Findings, Conclusions and Decision Public Works Variance EN-23-0010

Site: The Reserve Vault Location Variance
Parcel No. 0222323134

Re: **(EN-23-0010)** The Reserve Vault Location Variance - Public Works Variance Request

**RE: The Reserve — City file no. PL-PPLAT-22-0001, CPH Project No. 0228-21-001
Request for Public Works Standards Variance for Vault Location**

SITE PLAN - WEST

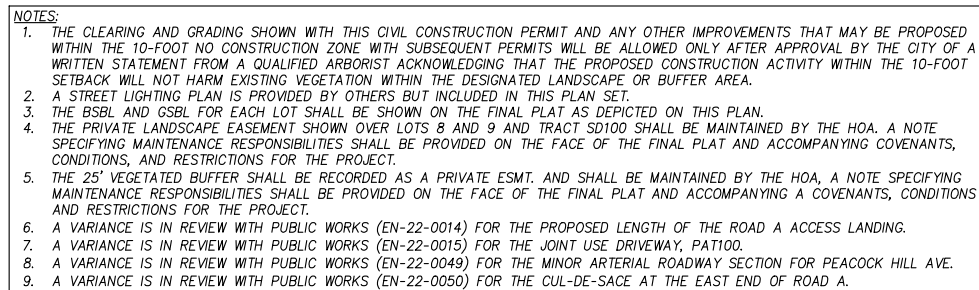
Strict compliance of the setback requirement presented in the Manual would result in two potential alterations to the proposed plat. The first alteration would result in a change in the plat layout and lot locations. With 14 units being the minimum unit count making this project financially infeasible, strict compliance with this setback requirement could be resolved by relocating Lot 7 to the current SD100 location and placing SD100, associated vault and access road within Lot 7 current position. This relocation would result in a less effective stormwater management system and earthwork balance. Locating the vault further west would have two significant impacts to the project grading. The detention vault is currently acting as a retaining wall at the east end of the development to assist in reducing fill material and disturbance of the existing vegetation and on-site steep slopes. With this retaining wall no longer available, Lot 7 would require 10-20 feet tall MSE walls in lieu of the detention vault. In this scenario, the grade of SD100 will need to be significantly raised so that stormwater from the east boundary of the plat can gravity drain into the vault. This alteration would provide strict compliance with the PWS but would be undesirable and impractical for residential access, earthwork balance, limiting retaining walls, and stormwater management. See Exhibits 2, Site Plan, West for current site layout and lot orientation

Strict compliance of the setback requirement presented in the Manual would result in two potential alterations to the proposed plat. The first alteration would result in a change in the plat layout and lot locations. With 14 units being the minimum unit count making this project financially infeasible, strict compliance with this setback requirement could be resolved by relocating Lot 7 to the current SD100 location and placing SD100, associated vault and access road within Lot 7 current position. This relocation would result in a less effective stormwater management system and earthwork balance. Locating the vault further west would have two significant impacts to the project grading. The detention vault is currently acting as a retaining wall at the east end of the development to assist in reducing fill material and disturbance of the existing vegetation and on-site steep slopes. With this retaining wall no longer available, Lot 7 would require 10-20 feet tall MSE walls in lieu of the detention vault. In this scenario, the grade of SD100 will need to be significantly raised so that stormwater from the east boundary of the plat can gravity drain into the vault. This alteration would provide strict compliance with the PWS but would be undesirable and impractical for residential access, earthwork balance, limiting retaining walls, and stormwater management. See Exhibits 2, Site Plan, West for current site layout and lot orientation.

The City Engineer's analysis concurs with the Applicant's claim that strict compliance is impractical due to the reasons stated by the applicant.

EXHIBIT 5 - OVERALL DRAINAGE PLAN

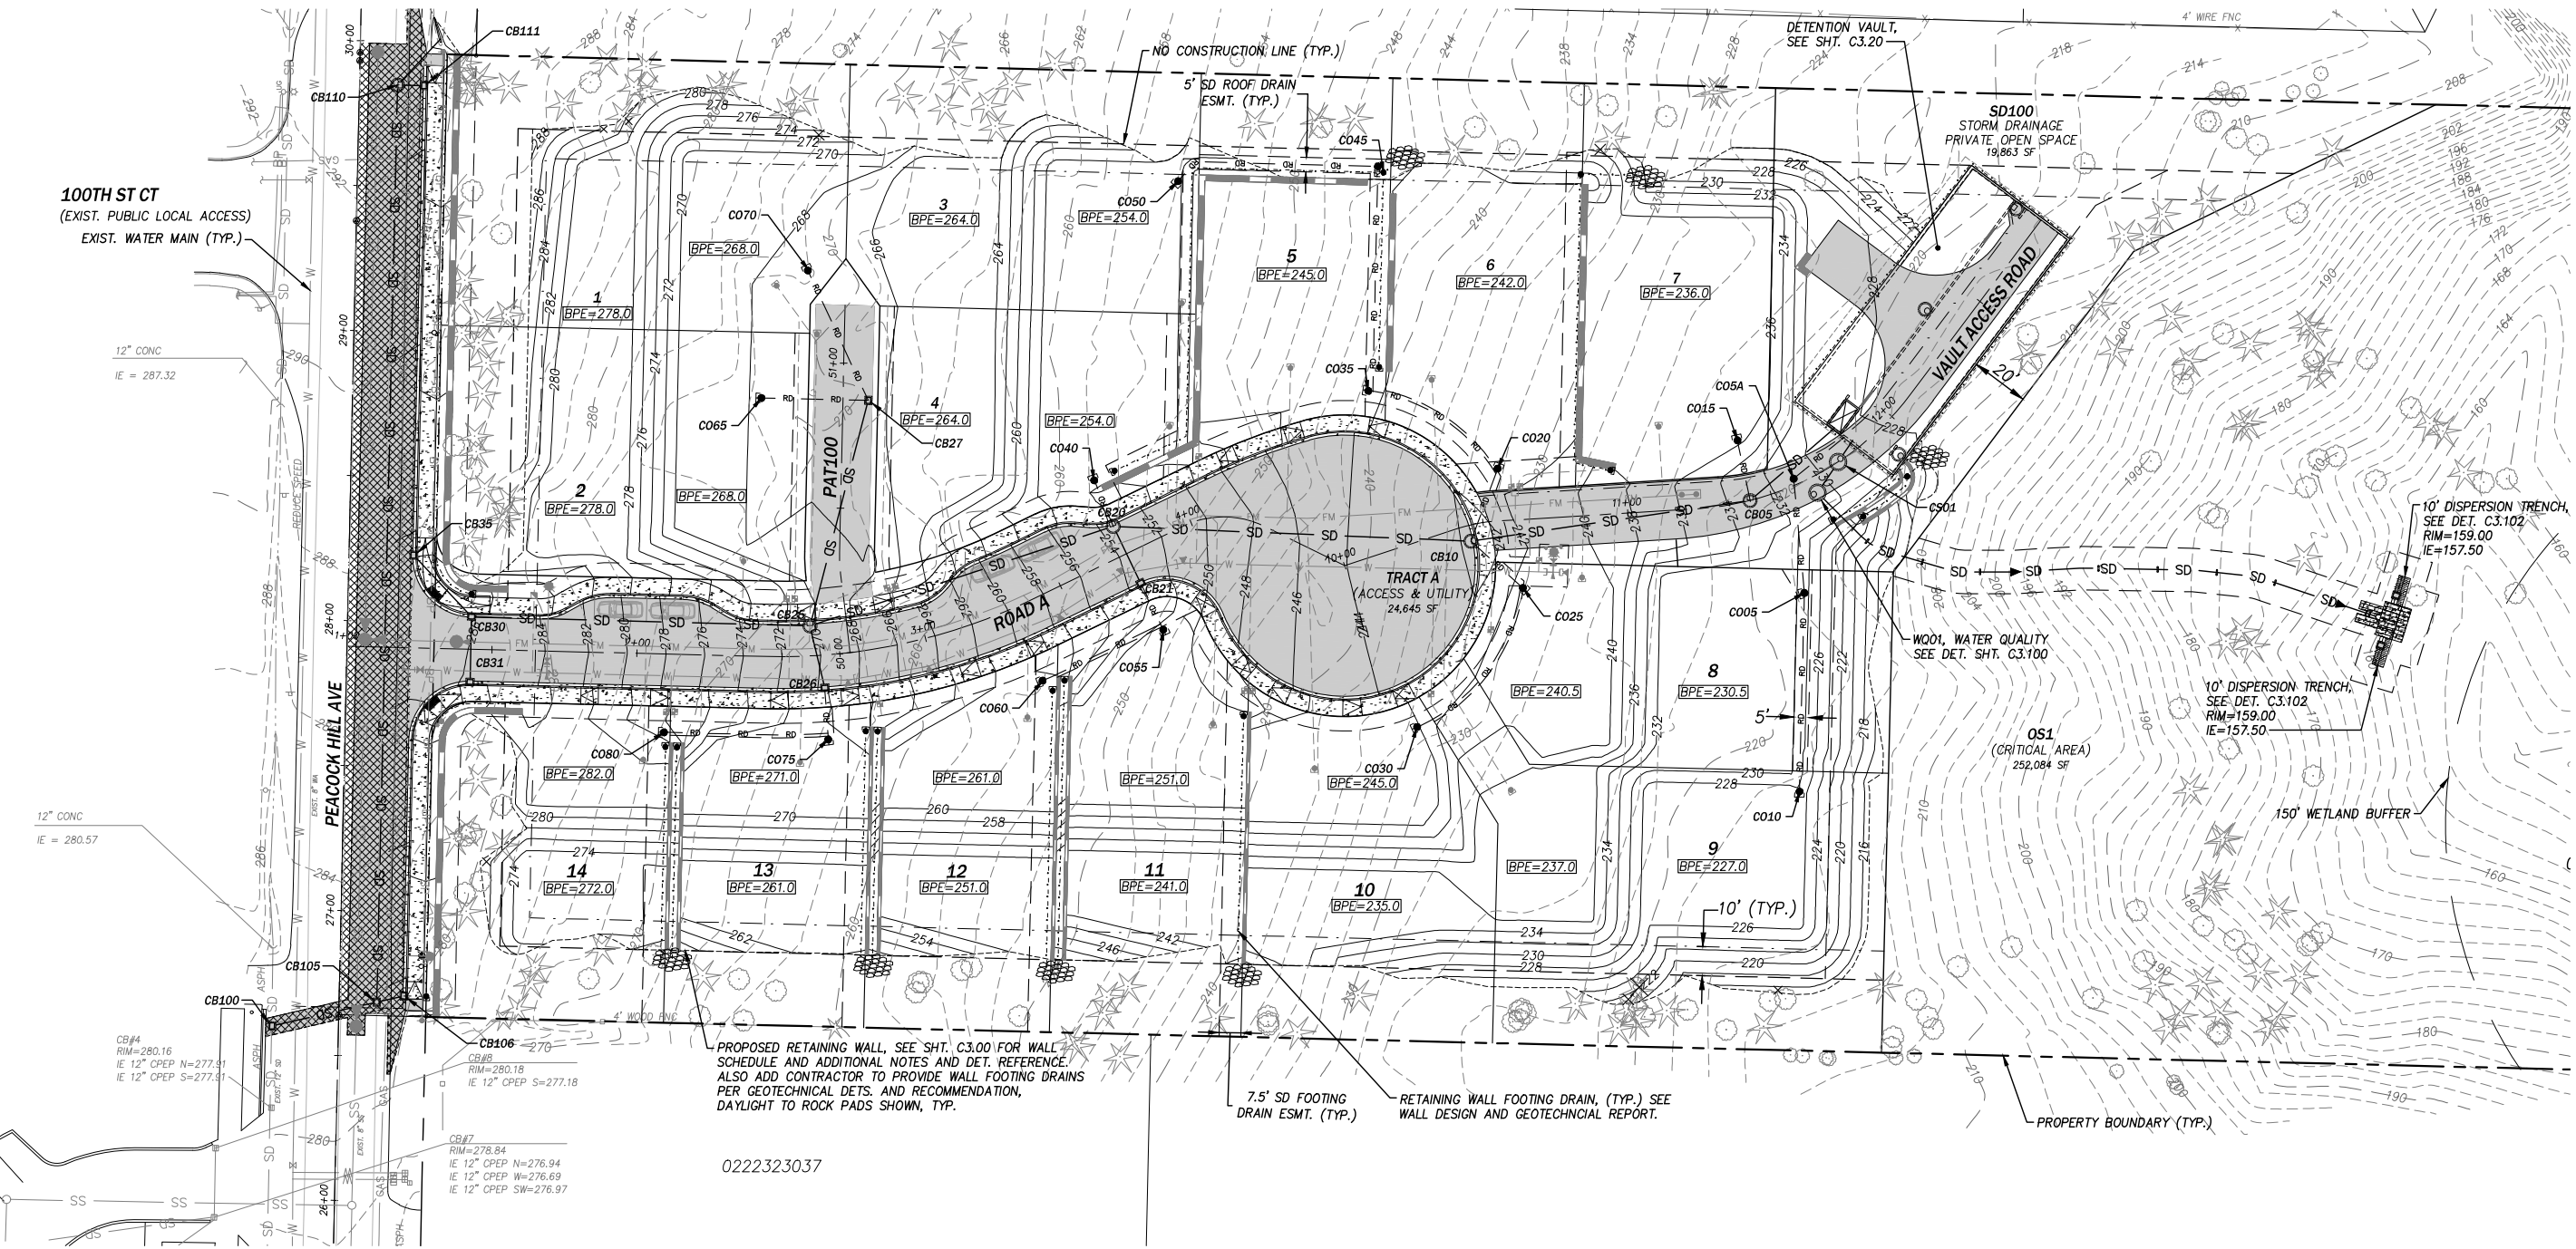
The proposed stormwater management plan for the project consists of a series of catch basin inlets connected by underground conveyance pipe systems that convey stormwater runoff to an underground detention vault. The detention vault provides control of the volume and release rate of stormwater per City standards. Controlled discharges from the site is treated per the Basic Water Quality requirements prior to being discharged to an HDPE tightline and a gabion basket and rock energy dissipator with rock dispersion trenches. The proposed storm drainage systems are shown on the enclosed Exhibit 5, *Overall Storm Drainage Plan*.
